March 10, 2023

Project Name: PEARL JUNIOR HIGH MULTIPURPOSE
Project No: 22-056
RE: Updated Civil and Structural drawings.

ADDENDUM NO. 01

BASEMENT FOUNDATION PLAN

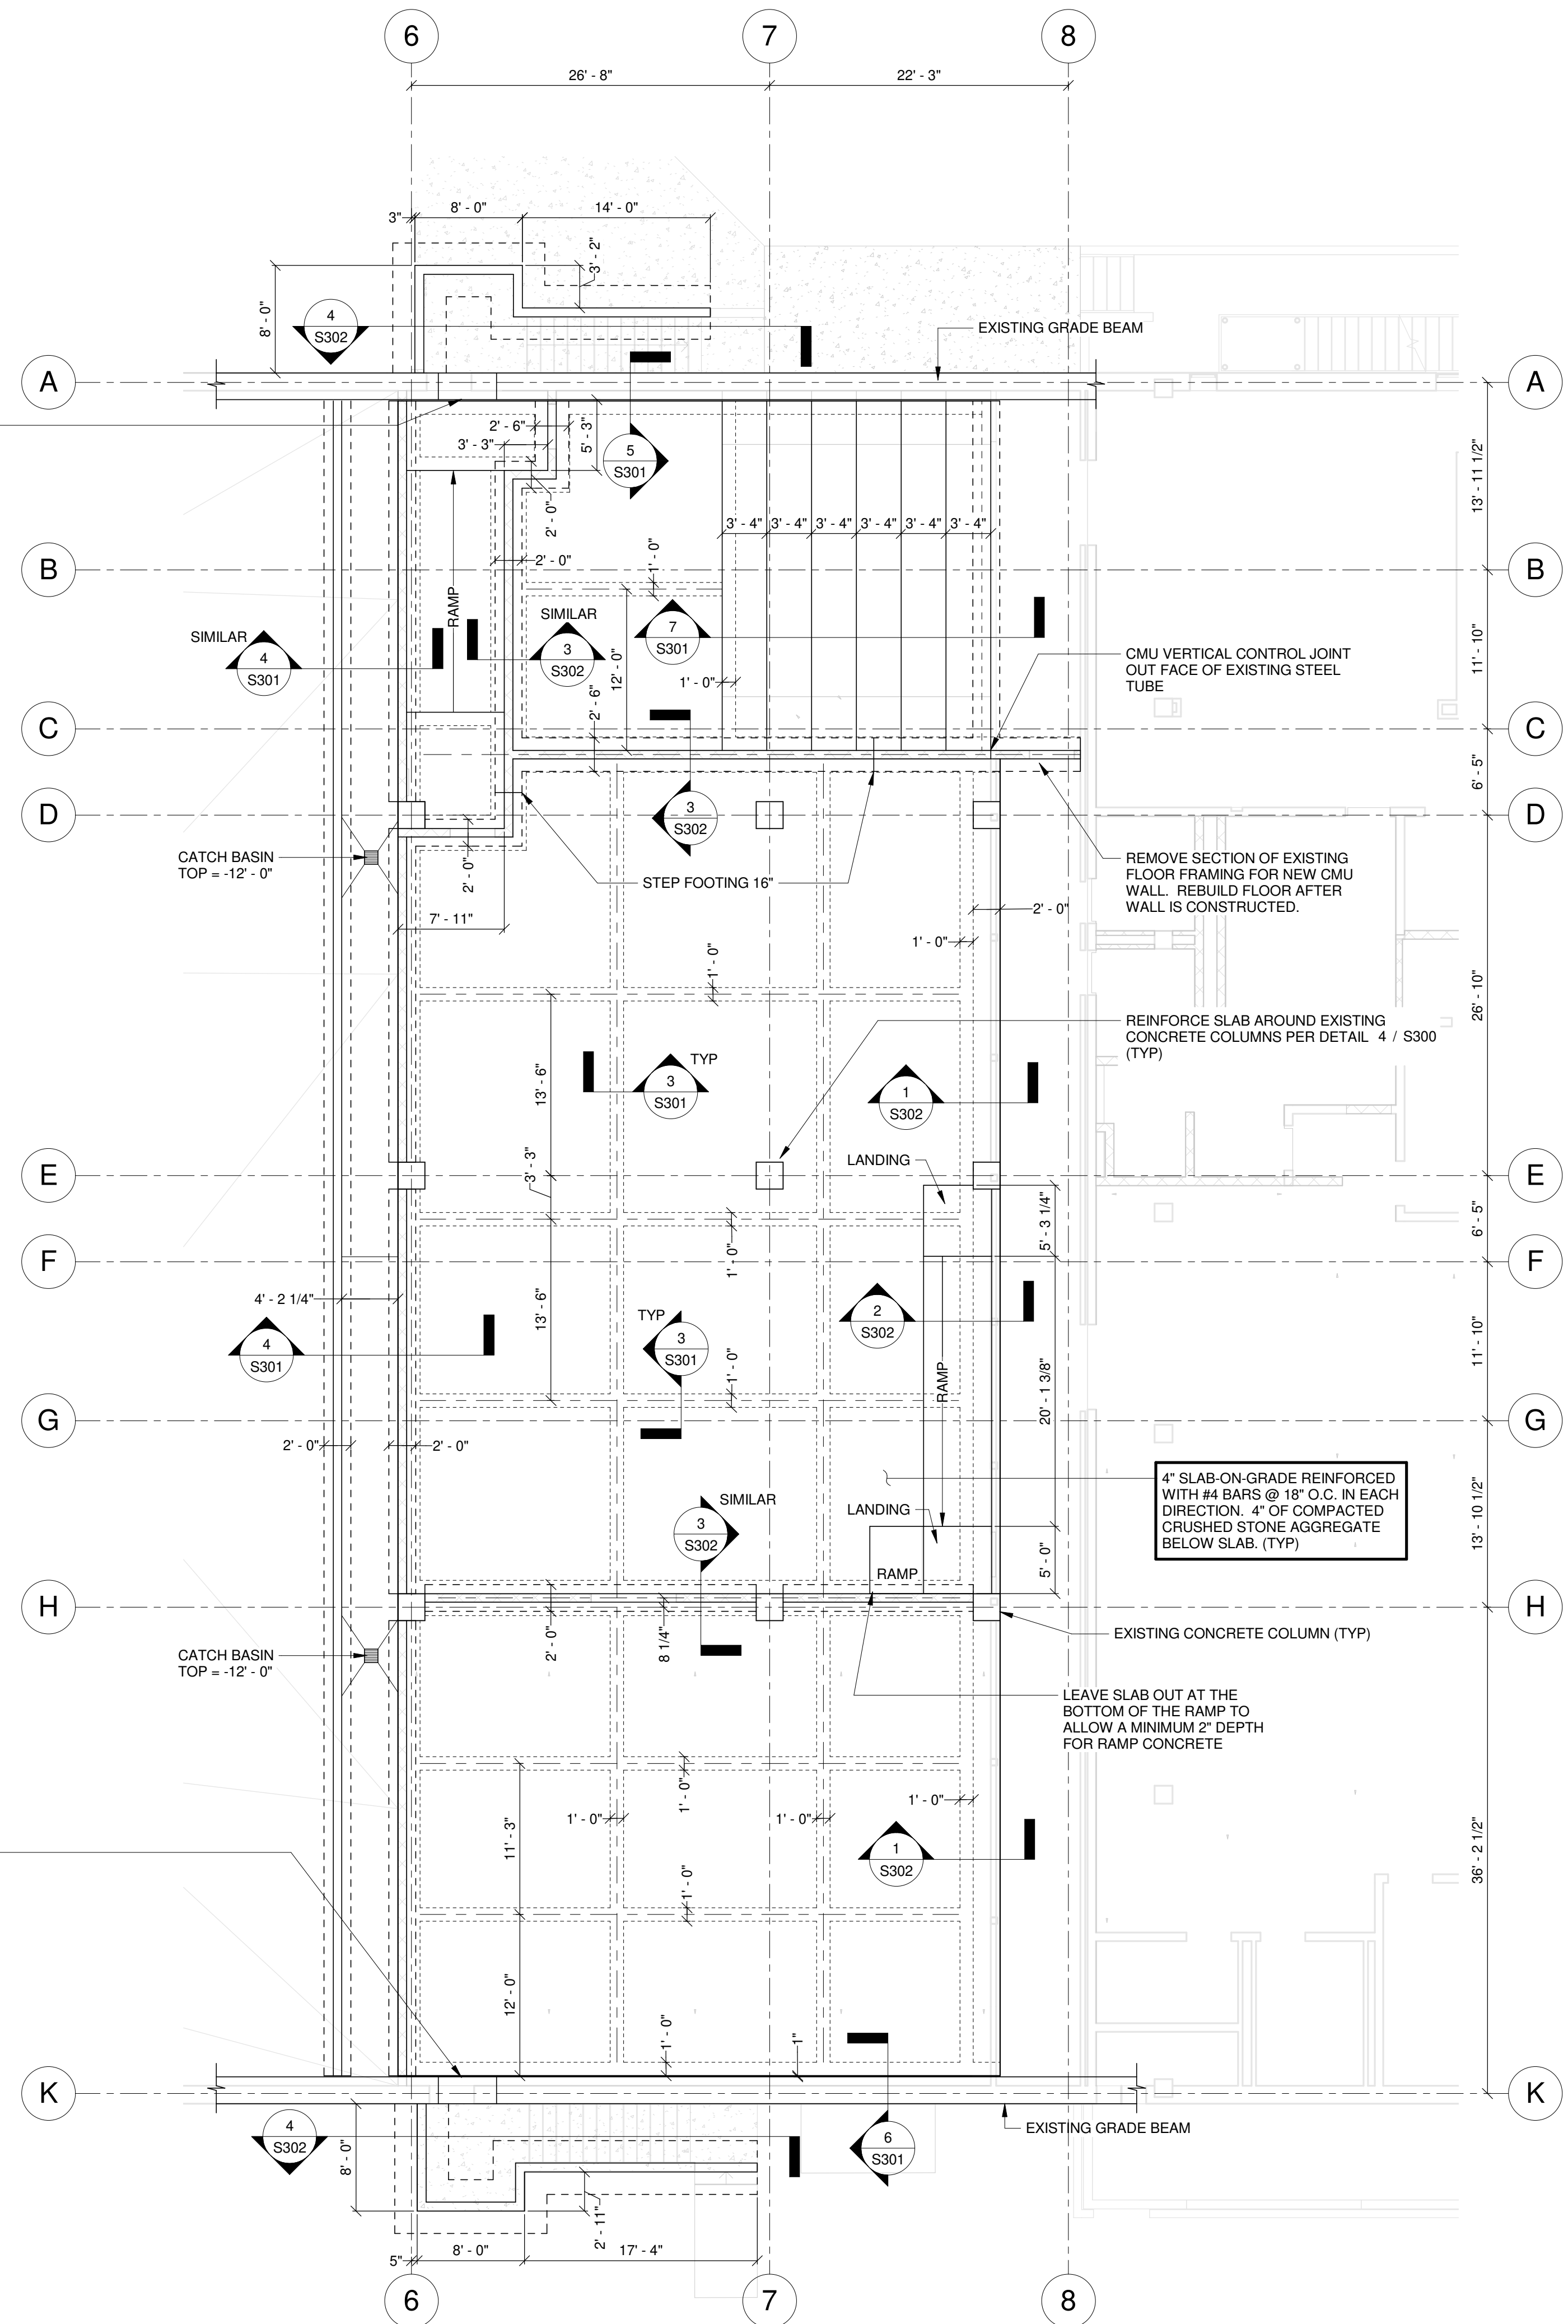
- S204 NEW ADDITION UPPER ROOF FRAMING PLAN
 - Modified basketball support condition.
 - S205 BASEMENT FOUNDATION PLAN – ALTERNATE 1
 - Modified information for cutting into existing grade beam for new door and added dimensions for exterior stairs.

1. UNDERPIN THE EXISTING GRADE BEAM WITH (4) HELICAL PILES WITH AN ALLOWABLE COMPRESSIVE CAPACITY OF 50 KIPS EACH.
2. CUT EXISTING GRADE BEAM FOR NEW DOOR OPENING. DO NOT CUT THE EXISTING CONCRETE COLUMN ON COLUMN LINE 6. THIS COLUMN IS 48" WIDE (FIELD VERIFY COLUMN LOCATION & SIZE).
3. INSTALL NEW GALVANIZED L5X3X1/4 LOOSE LINTEL TO SUPPORT BRICK ABOVE NEW OPENING.
4. INCLUDE NEW CMU LINTEL IN CONTRACT PRICE. L6X3X3/8 ANGLE ON EACH SIDE OF THE EXISTING CMU WALL BOLTED TOGETHER THROUGH THE WALL WITH 5/8" BOLTS @ 12" O.C.
5. THE STRUCTURAL ENGINEER MUST BE CONSULTED ONCE EXISTING CONDITIONS HAVE BEEN FULLY EXPOSED, PRIOR TO CUTTING THE DOOR OPENING.
